**Sent:** 15/04/2024 8:17:59 AM  
**Subject:** DA2023/832 Objections  
**Attachments:** Leplatrier 15-04-24.pdf;

OBJECTIONS TO DA AMENDMENT 12-04-24

From Robert Story and Susan Duncan Story

DRG-1.3 14/04/24  
 LEPLASTRIER HOUSE  
 SITE MEASUREMENTS EMA TO BOUNDARY  
 SECTION AA DRG-1.1

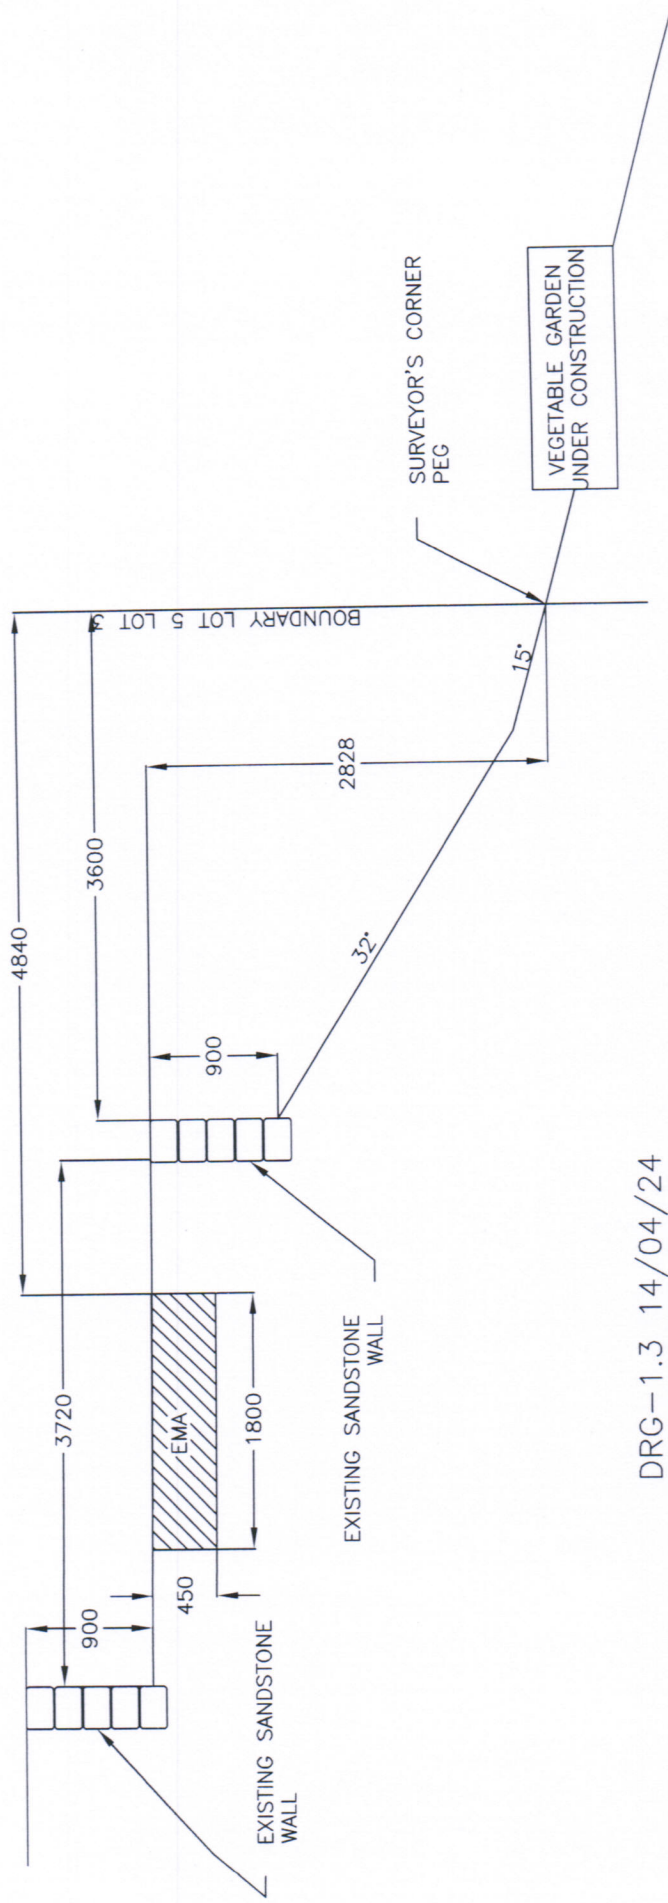
- 1) The EMA is located between 2 existing sandstone walls. This fixes position.
- 2) There is an existing surveyor's peg on the property boundary of Lot 3 and Lot 5.
- 3) Site measurements were taken as depicted on DRG 1.3 and location of section on DRG 1.1. See below.
- 4) The setback of the EMA to Lot 3 is 4.84 metres and not the 6.2 metres as indicated by Broadcrest.
- 5) The EMA is a pressurized system so any pipe breakage would result in effluent flowing down to Lot 3.
- 6) There is an underlying clay layer in the area so effluent would reach this layer and permeate to Lot 3.

From this investigation, the EMA as depicted on Broadcrest's report cannot be located in this position. If it is approved in this position, there will be no choice but to take further action.
